563- 573 Riverside street, Portland, ME

Amendment to Plan - Six G's Coed LL

Six Gs Coed, LLC

This letter and the enclosed plans are provided in response to the review comments regarding the above referenced project as contained in your letter dated December 12, 2003 and the memorandum from Stephen Bushey, P.E., of DeLuca-Hoffman Associates, Inc., dated December 3, 2003.

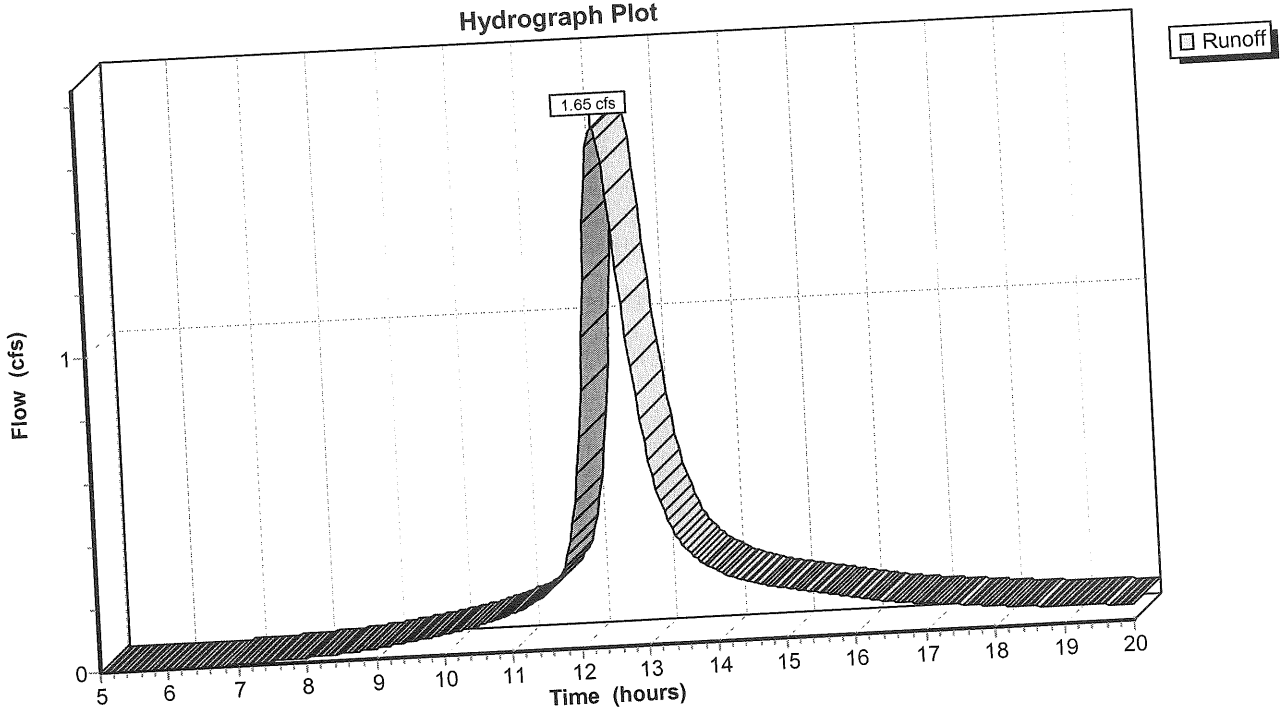
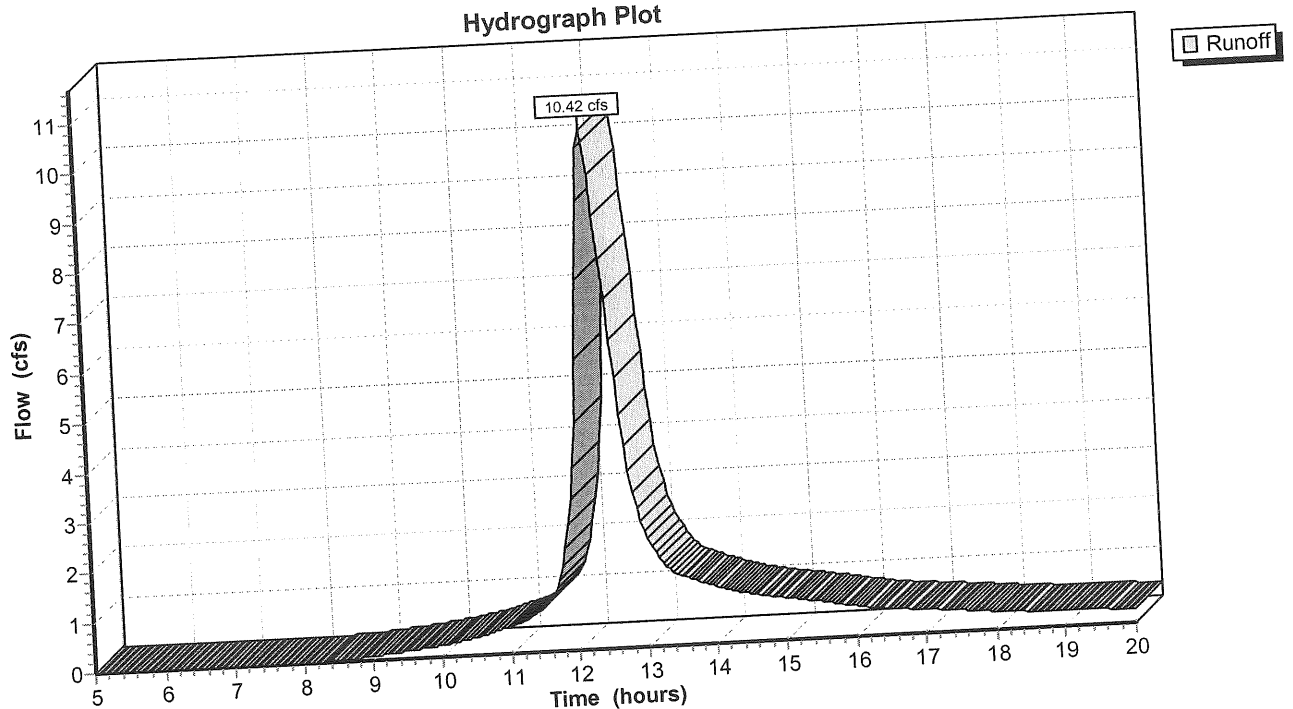
7. The post development watershed plan appears to break watersheds 3S and 4S down the middle of the building (assuming a peaked roof line). The building elevations suggest a single pitched roof from front to back; therefore the entire building should be included in area 3S. The runoff computations should be rerun, although I suspect that the conclusions will remain the same.

*The HydroCAD stormwater model was revised in response to the single pitched roof from front to back. The results indicate a reduction in the peak rate of runoff at Study Point 4 and an increase at Study Point 3. This is a more desirable outcome in that a slight increase in peak rates of runoff was originally calculated at Study Point 4 and a slight decrease was calculated at Study Point 3, in comparison to the existing condition.*

## SUBSURFACE WASTEWATER DISPOSAL PLAN

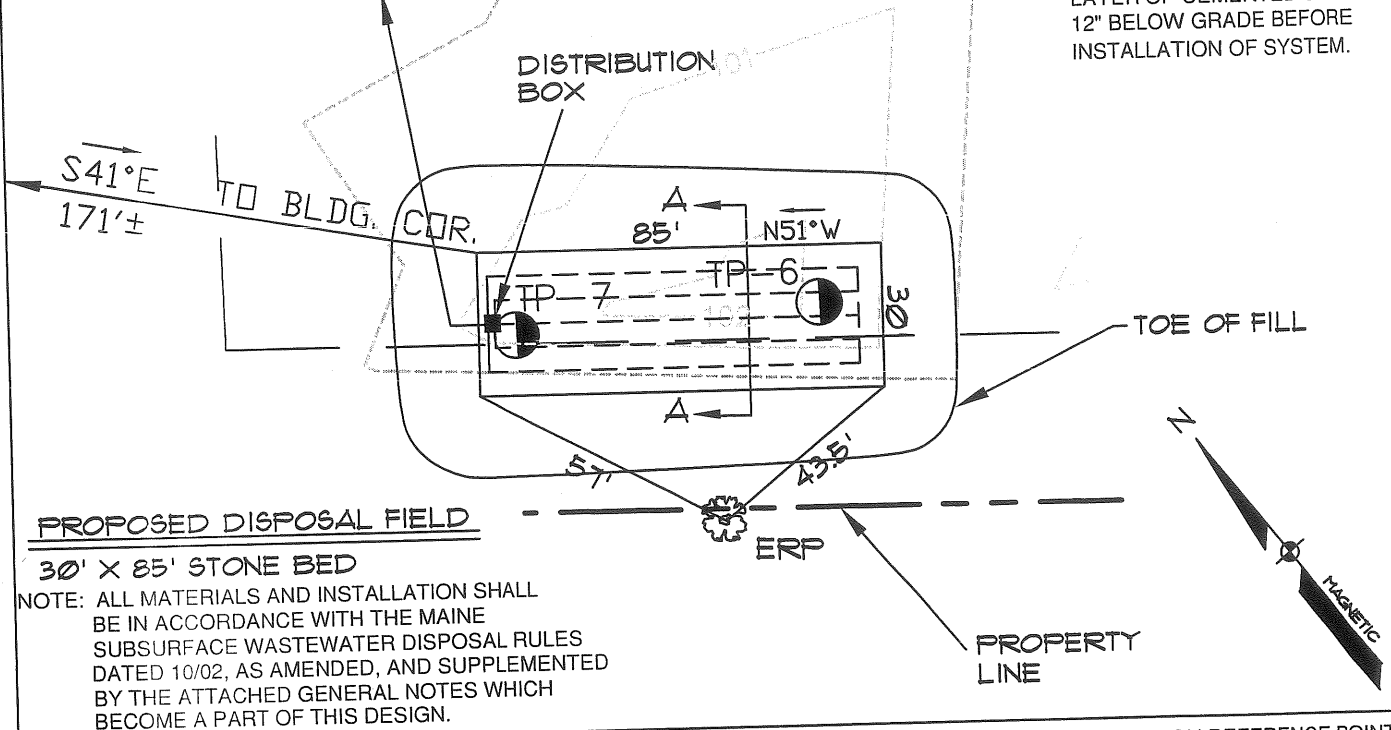
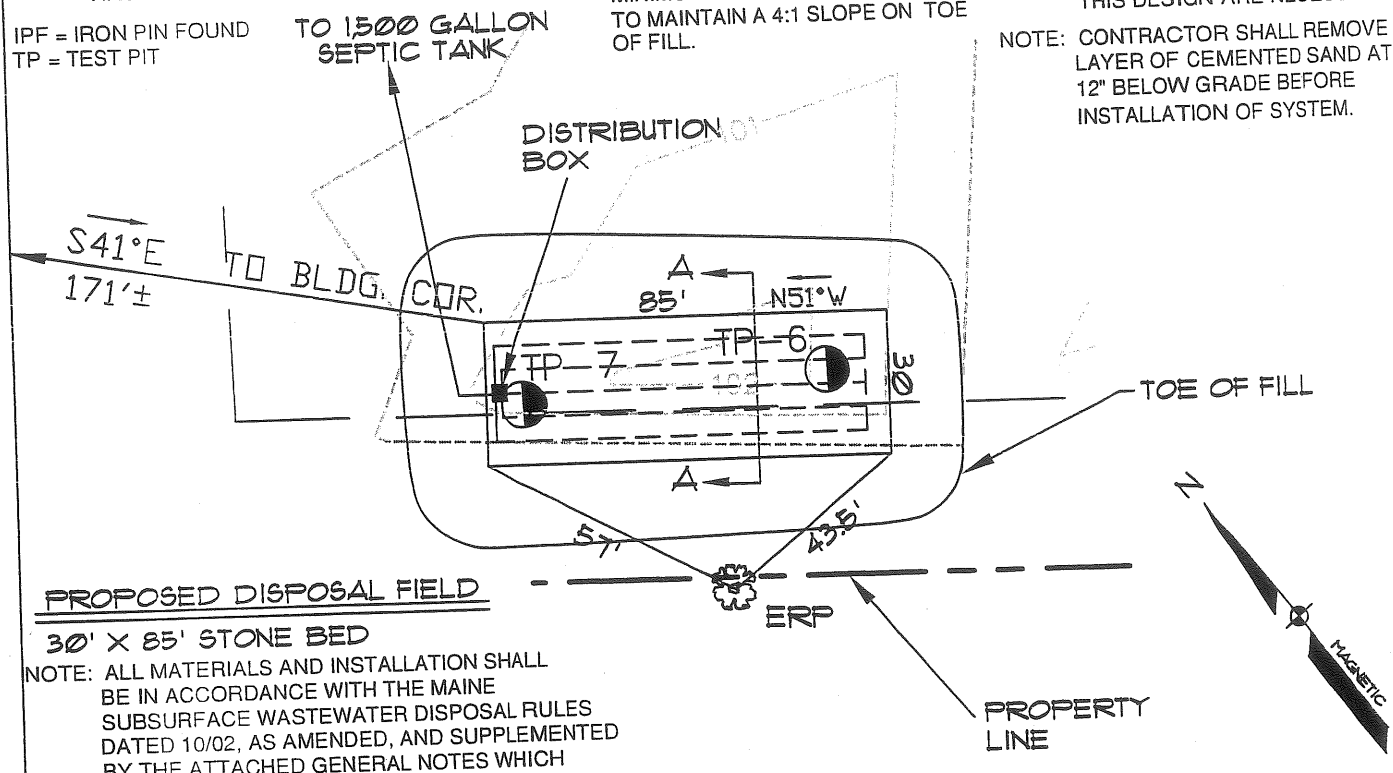
2. The applicant must provide the City's plumbing inspector with the necessary completed HHE-200 forms and relevant information of adjacent properties, wells, and adjacent systems if they exist. A licensed soils evaluator must complete these materials.

*Enclosed are the required HHE-200 forms for the proposed subsurface sewage disposal system. Additionally, the system and its corresponding grading are depicted on the Grading & Utility Plan.*
